# ARIZONA DEPARTMENT OF ENVIRONMENTAL QUALITY

September 11, 2017

FPU18-043

RE: WAFB – ADEQ evaluation - *Response to ADEQ Comments Dated 16 May 2017 On Site ST012 Contaminant Mass Estimation Process. LNAPL Volume Calcs; Received March 23, 2017. An ADOBE.PDF of Amec Foster Wheeler (AMEC), Assorted Light Nonaqueous Phase Liquid (LNAPL) Volume Calculations;* from various time intervals between 2015 and 2017. Prepared for US EPA, San Francisco, CA, and ADEQ, Phoenix, AZ; prepared by AFCEC/CIBW, Dept. of the Air Force, Rome, NY; dated August 14, 2017.

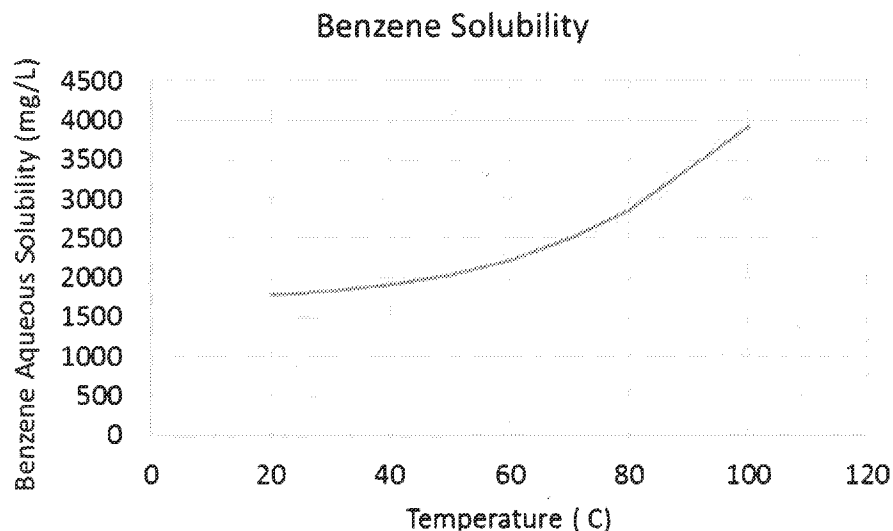
Benzene solubility in water is a relatively weak function of temperature since this compound has a relatively low molecular weight. A graph of the theoretical solubility as a function of temperature is provided below. At 100 C, the benzene solubility is only about twice the solubility at 25 C. Hence, the benzene concentrations measured in zones with elevated temperature would not be expected to decrease by any more than a factor of two with cooling of the site to ambient conditions.
